### Clarification 1

نمبر سند	TES/2019/W-84	
پراجیکٹ	Design and Build of 100 Housing Units at M.Kolhufushi	
نمبر	29 <sup>th</sup> July 2019	
نمبر	Boq: -01	Drawings: -02
نمبر	No. of Pages: -02

**Design and Construction of  
100 Housing Units at M. Kolhufushi**

## Sample layout for Type 2

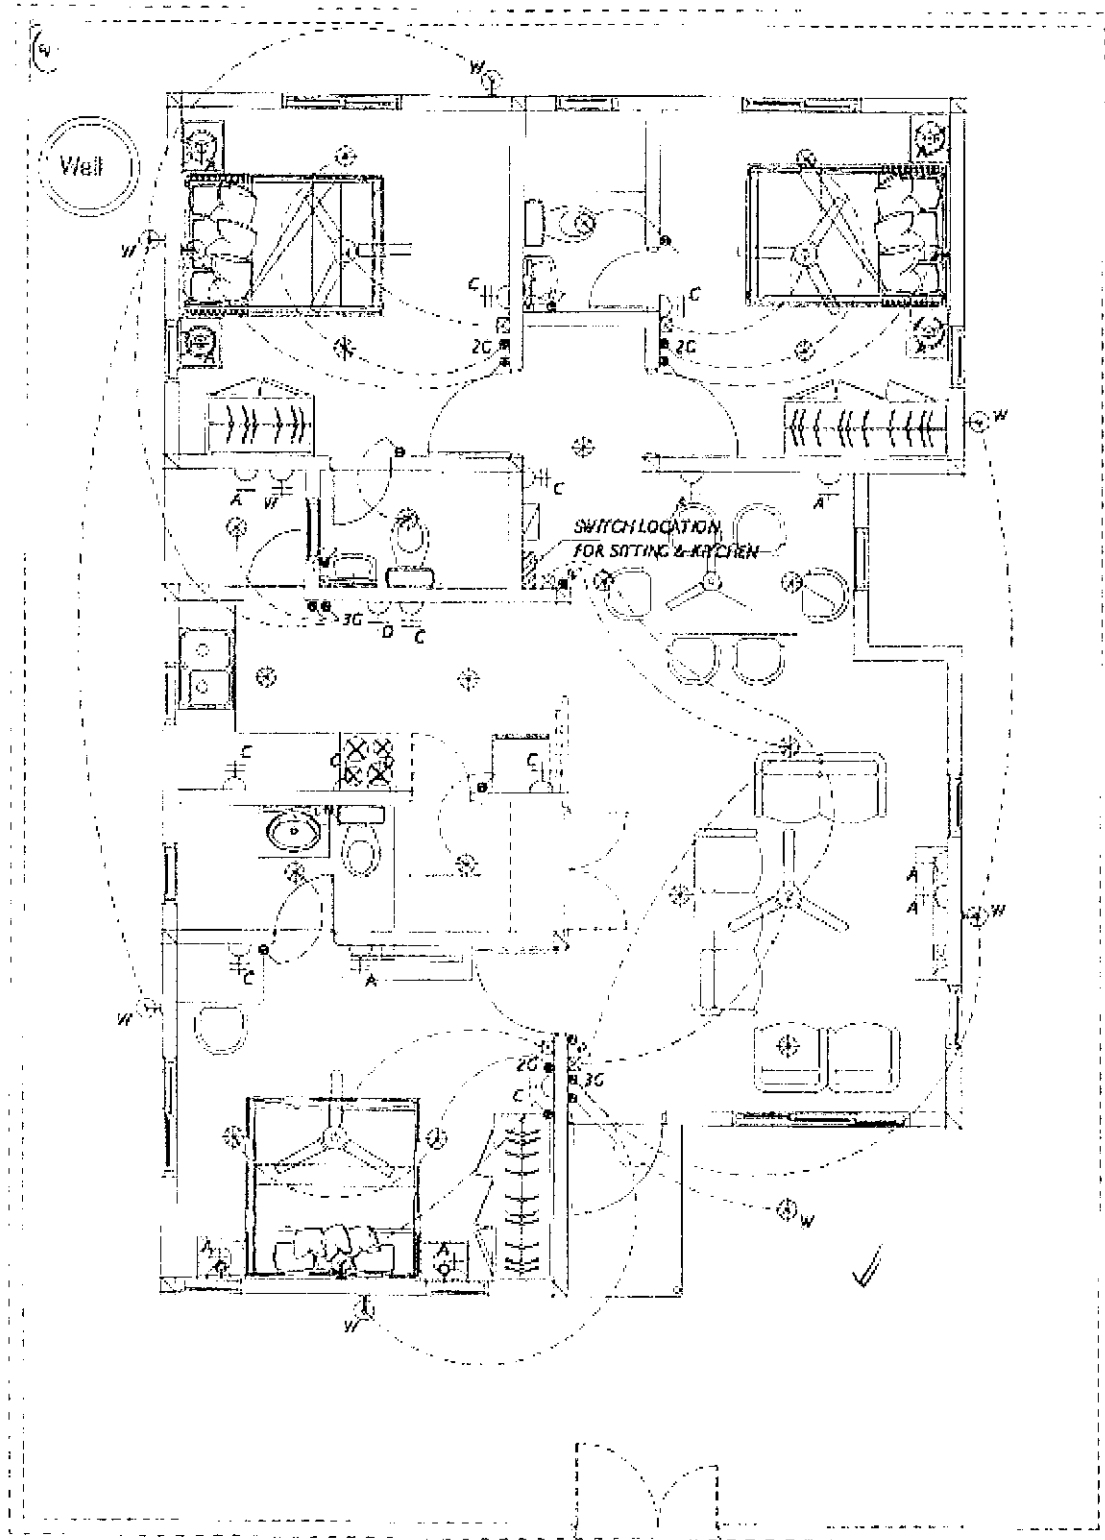
6. Please provide the quantity for proposed elongated and square plots?

The selected Contractor is required to conduct the survey to determine the plot shapes.
